Access Compliance Report

Public Rights-of-Way (Curb Ramps)

Intersection ID: 9560	Main Street: LUCKY_PENNY_ST	Cross Street: FREEDOM_DR	Location: SE
ADA ID: AD568241A202	Ramp Type: Perp	Initial Pass/Fail: Fail	Overall Compliance: No
Severity Score: 22.5			
Codes/Mitigation Info/Possible Solution		Field Measurements/Component Compliance

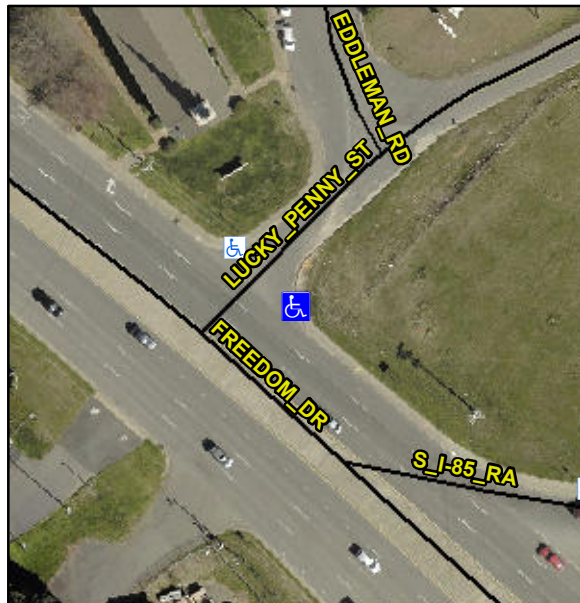
Not Found, R304.5.1, R304.2.2, R304.5.3

Compliance	Description	Data	Compliance	Description	Data
N/A	Ramp Length (in)	48.0	No	Ramp Slope (%)	10.3
No	Ramp Width (in)	40.0	No	Ramp XSlope (%)	3.3
N/A	Flare Type LT	N/A	N/A	Flare Type RT	N/A
N/A	Flare Slope LT (%)	N/A	N/A	Flare Slope RT (%)	N/A
N/A	Flare Traversable LT?	N/A	N/A	Flare Traversable RT?	N/A
N/A	Landing Length (in)	N/A	N/A	DWS Provided?	N/A
N/A	Landing Width (in)	N/A	N/A	DWS Contrast?	N/A
N/A	Landing Slope (%)	N/A	N/A	DWS Length (in)	N/A
N/A	Landing X Slope (%)	N/A	N/A	DWS Full Width?	N/A
N/A	Landing Curb? (Y/N)	N/A	N/A	DWS Offset (in)	N/A
N/A	Shared Landing?	N/A			
N/A	Gutter Ponding?	N/A	N/A	Gutter Slope (%)	N/A
N/A	Gutter Lip Ht (in)	N/A	N/A	Gutter X Slope (%)	N/A
N/A	Painted X Walk1?	No	N/A	Painted X Walk2?	N/A
	X Walk 1 Direction	To NW		X Walk 2 Direction	N/A
N/A	X Walk 1 Width (in)	N/A	N/A	X Walk 2 Width (in)	N/A
	X Walk 1 Slope (%)	4.0		X Walk 2 Slope (%)	N/A
	X Walk 1 X Slope (%)	7.8		X Walk 2 X Slope (%)	N/A

Remove & Replace Entire Ramp.
